LOST CREEK ISR, LLC

Re: Reply to a Notice of Violation
Lost Creek ISR Project License SUA-1598, Docket 040-09068

REPORT FOR SERP LC16-07

Proposed Action: *To review and edit the Organizational Chart and Section 5 in the NRC Technical Report to be consistent with the current Lost Creek Organizational Chart.*

Figure 5.1-1 Lost Creek ISR, LLC Organization Chart

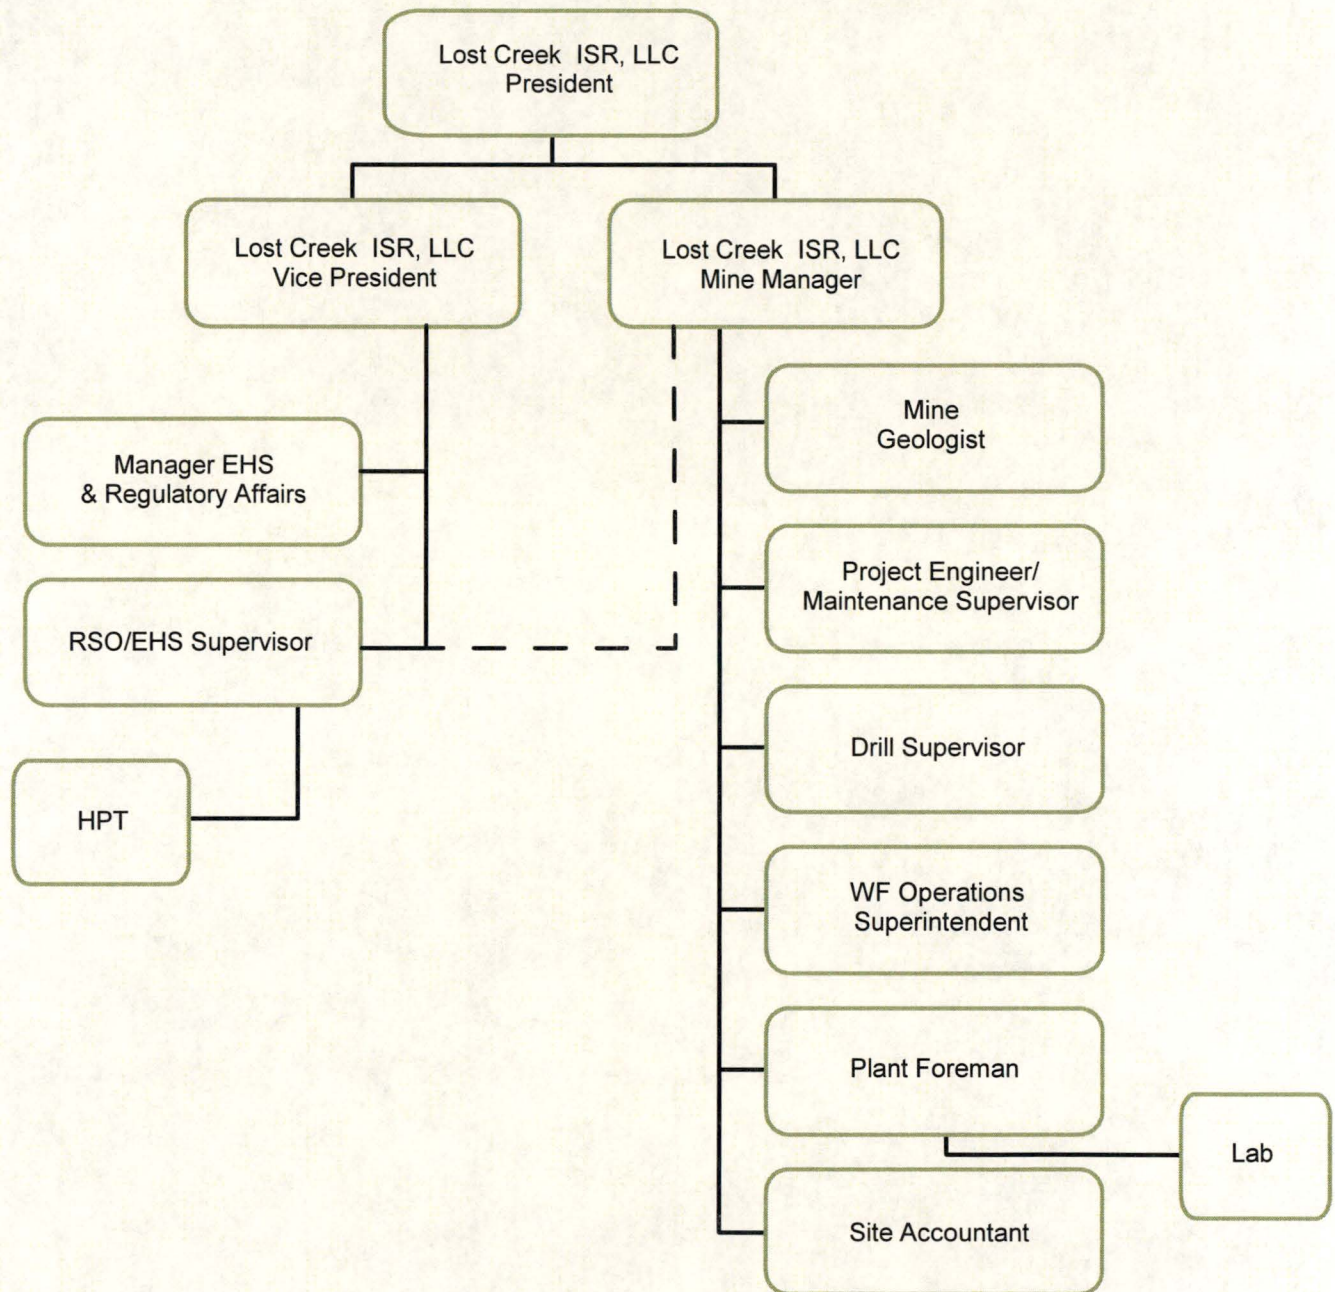
- Drill Supervisor was removed from Department Heads and placed under the Mine Geologist
- Wellfield Operations Superintendent was split into the Department Heads of Wellfield Operations Supervisor and Wellfield Construction Supervisor.
- The Site Accountant was removed from the Department Heads
- EHS Supervisor was removed from the RSO title (the RSO responsibilities do not change as a result).
- The Department Head of Plant Foreman was changed to Plant Manager
- References to General Manager or Operations Manager were removed since those positions are not part of the LC organizational structure. The Vice Presidents, Manager

The changes to the TR Section 5 and Figure 5.1-1 were approved by the SERP. Footnotes will be added to the LC Org Chart to reference the positions as described in the TR if the job titles differ slightly.

Revise Technical Report Section 5.1 and associated Figure 5.1-1 to be consistent with current Lost Creek Project organizational structure.
